Project	<b>IEEE 802.16 Broadband Wireless Access Working Group</b> < <a href="http://ieee802.org/16">http://ieee802.org/16</a> >	
Title	<b>MSS Idle Mode</b>	
Date Submitted	<b>2004-03-18</b>	
Source(s)	Phillip Barber Broadband Mobile Technologies, Inc. 8302 Sebastian Inlet Frisco, Tx 75035	Voice: +1 (972) 365-6314 Fax: +1 (925) 396-0269 <a href="mailto:pbarber@BroadbandMobileTech.com">[mailto:pbarber@BroadbandMobileTech.com]</a>
	Yigal Leiba Runcom Ltd. Hachoma 2 St. 75655 Rishon Lezion, Israel	Voice: +972-3-9528440 Fax: +972-3-9528805 <a href="mailto:yigall@runcom.co.il">[mailto:yigall@runcom.co.il]</a>
	Changhoi Koo Samsung Elec. 416, Maetan-3dong, Youngtong-gu Suwon-si, Gyeonggi-do Korea	Voice: +82-31-279-5091 Fax: +82-31-279-5130 <a href="mailto:chkoo@samsung.com">[mailto:chkoo@samsung.com]</a>
	Prakash Iyer Intel JF3-206, 2111 NE 25th Avenue Hillsboro, Oregon 97124	Voice: +503 264 1815 Fax: +503 264 4230 <a href="mailto:prakash.iyer@intel.com">[mailto:prakash.iyer@intel.com]</a>

Re:	Response to IEEE 802.16e-4/06 (Call for Contributions on IEEE 802.16e/D1)	
Abstract	MSS Idle Mode	
Purpose	Provide for a mechanism for MSS to be detached from active Normal Operation service with

**Figure 1: Paging-groups example**

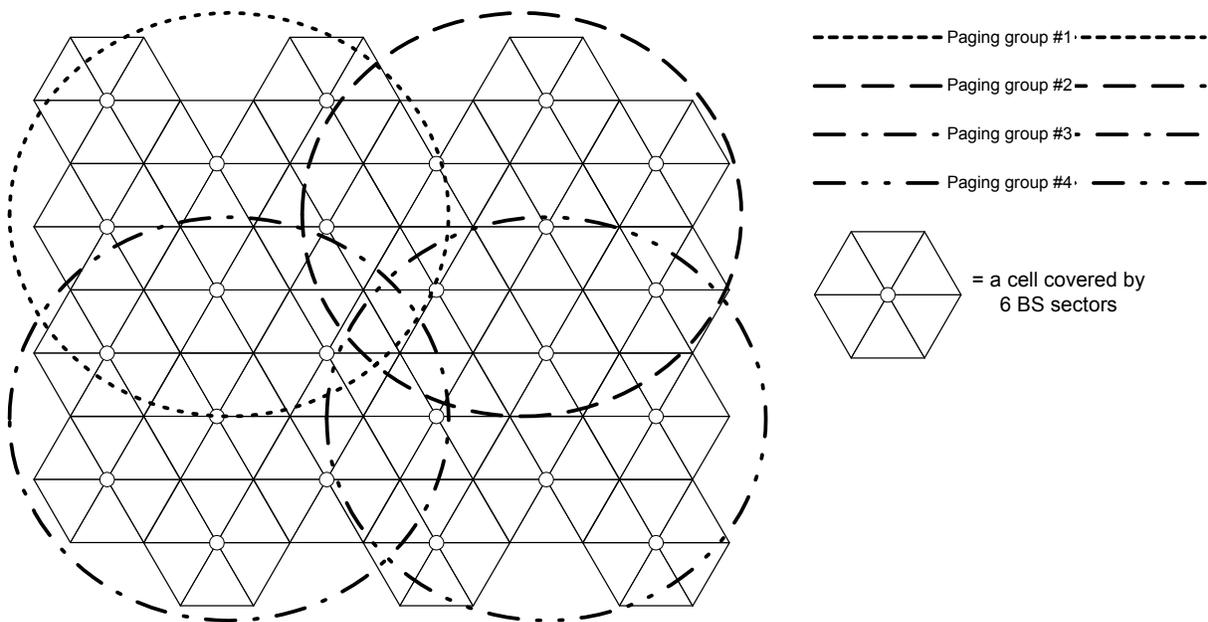
The BS are divided into logical groups called paging groups. The purpose of these groups is to offer a contiguous coverage region in which the MSS does not need to transmit in the UL, yet can be paged in the DL if there is traffic targeted at it. The paging groups should be large enough so that most MSS will remain most of the time within the same paging group, and small enough such that the paging overhead is reasonable. Figure 2 shows an example of four paging groups defined over multiple BS arranged in a hexagonal grid. A BS may be a member of one or more Paging Groups.

The paging-groups are defined in the management system. One possible method of definition is by using the **paging-group-action** backbone message. Another backbone message, **paging-announce**, is used to initiate paging of the MSS on all BS belonging to the paging group.
